Generally located 1/4 mile north of W. Chinden Blvd. and 1/2 mile west of N. Black Cat Rd., in the south 1/2 of Section 21, T.4N., R.1W.

Final plat consisting of 95 buildable lots and 18 common/other lots on 12.63 acres of land in the R-8 and R-15 zoning districts for the second phase of Pollard North Subdivision.

SHEET 2 OF 5

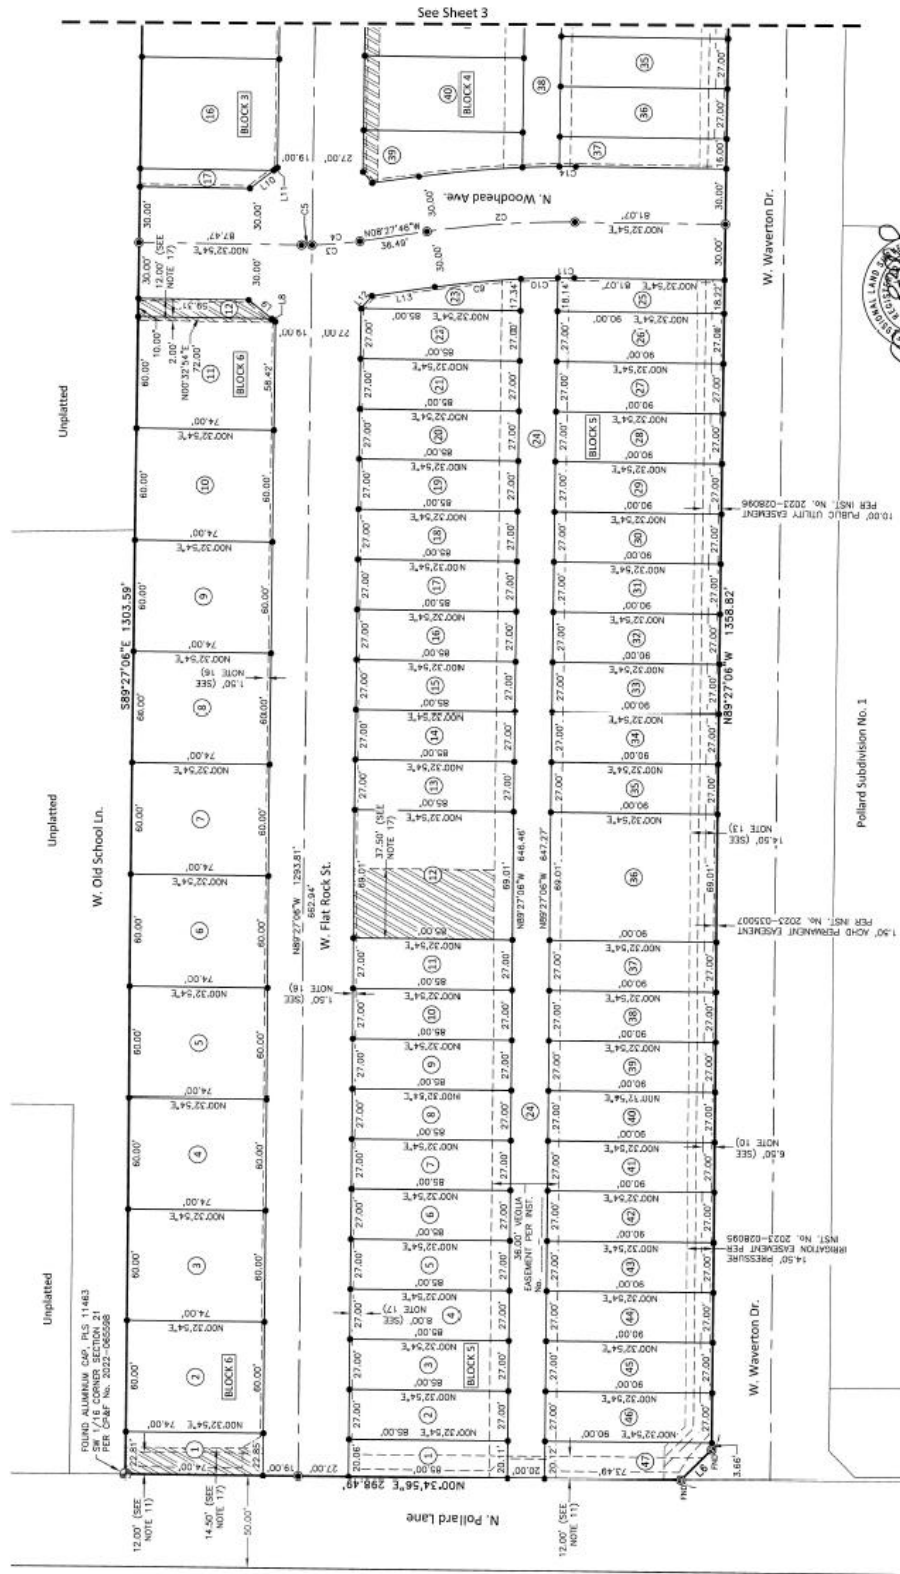
- g. Under References on Sheet 1: R5 – Include the book and page numbers of the recorded plat for phase 1.
 - h. Include the recorded instrument number of the Veolia easements graphically depicted on Sheet 2.

NOB NO.	24-296	SHEET 4 OF 5
---------	--------	--------------

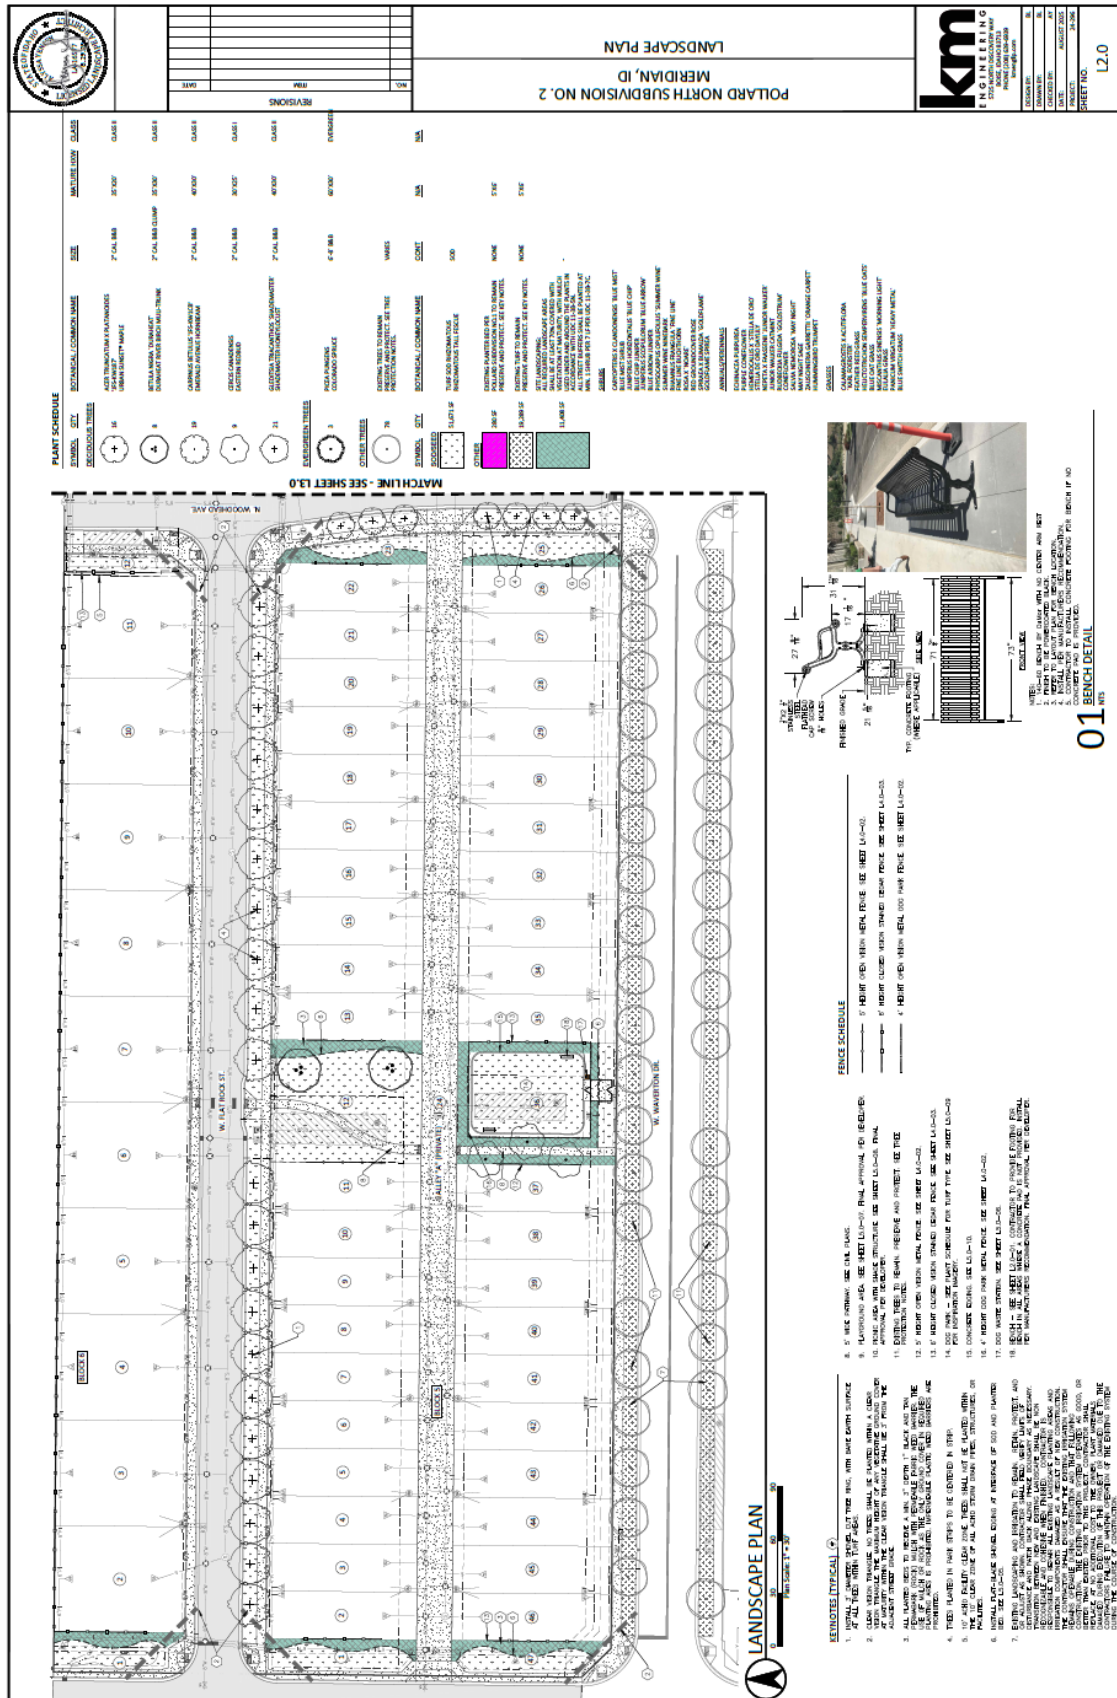
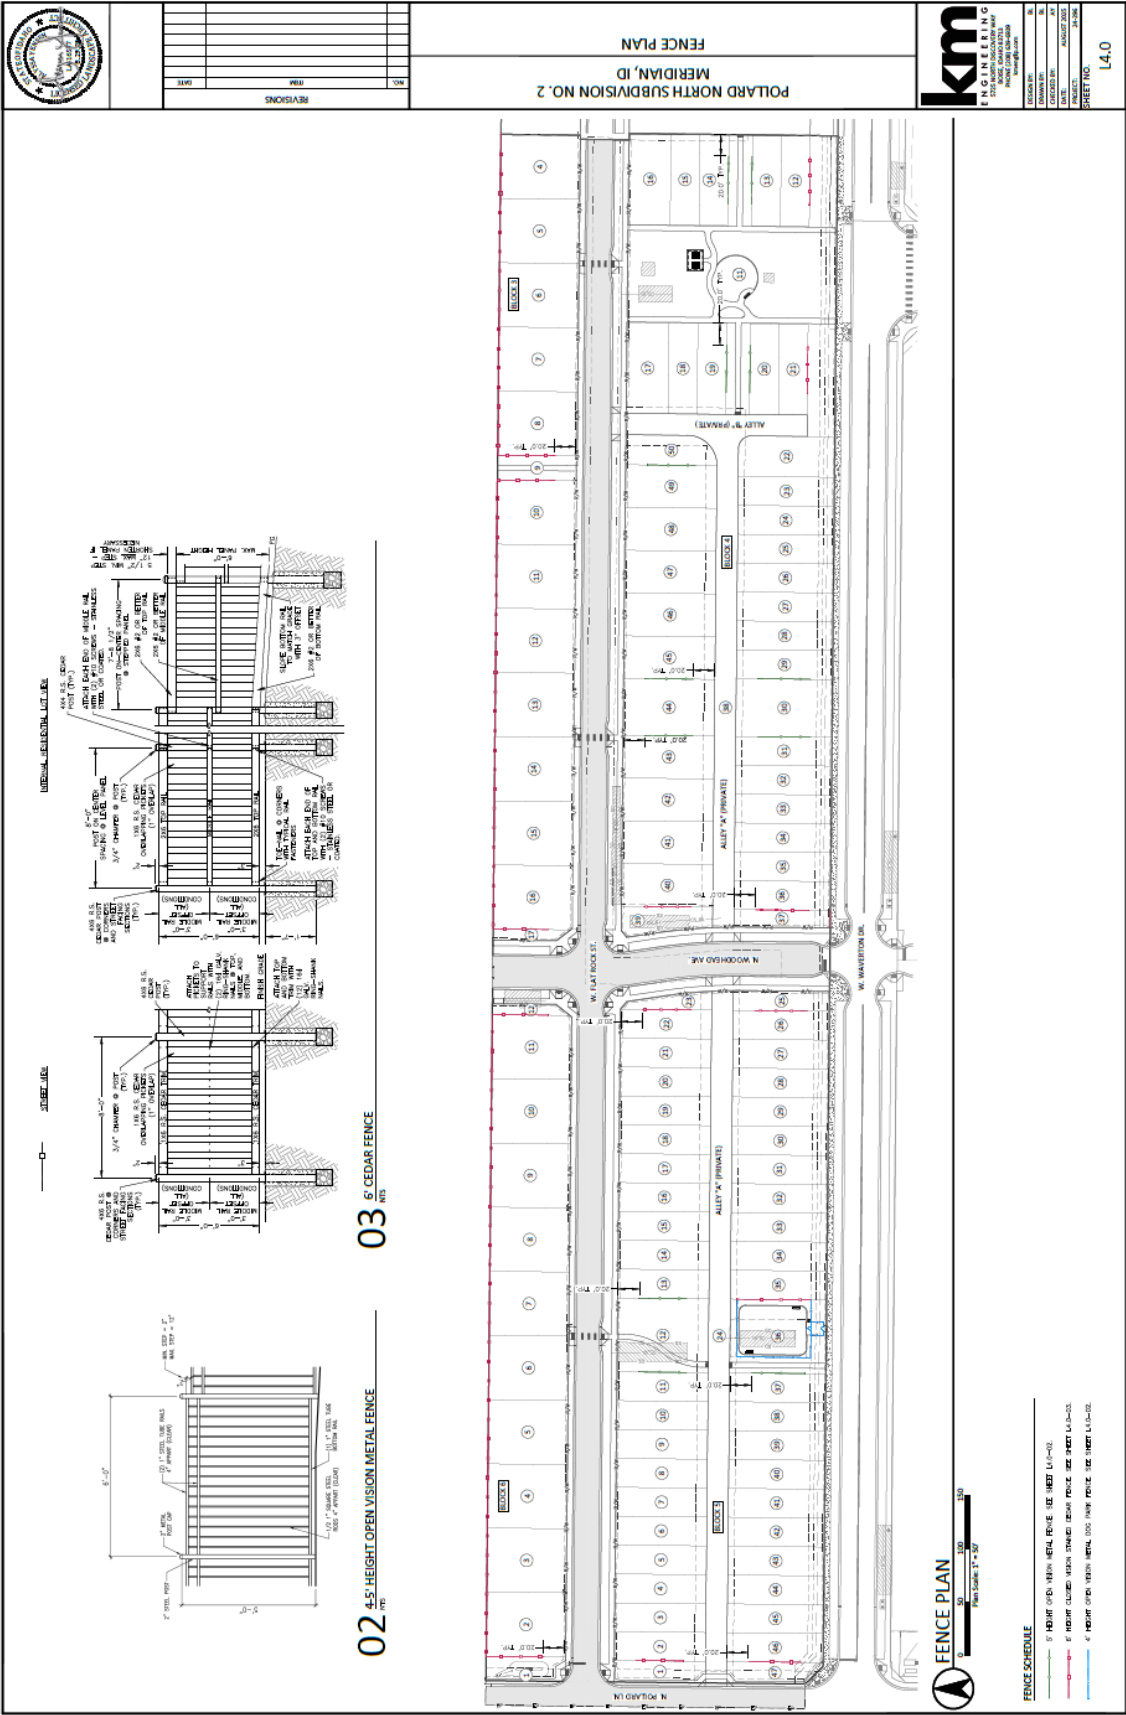
- a. Certificate of Owners (Sheet 4) – Include the book and page number(s) of the recorded plat for Pollard North Subdivision No. 1.
 - b. Plat note #4: Include the recorded instrument number of the development agreement (i.e. #2025-029554).

- c. Plat note #12: Delete note as it's not applicable to this phase.
 - d. Plat note #16: Include the recorded instrument number of the ACHD public right-of-way easement (sidewalk).

- e. Plat note #18: Include the recorded instrument number of the ACHD landscape license agreement.
 - f. Include the CP&F No. near the northeast corner on Sheets 1 and 3.
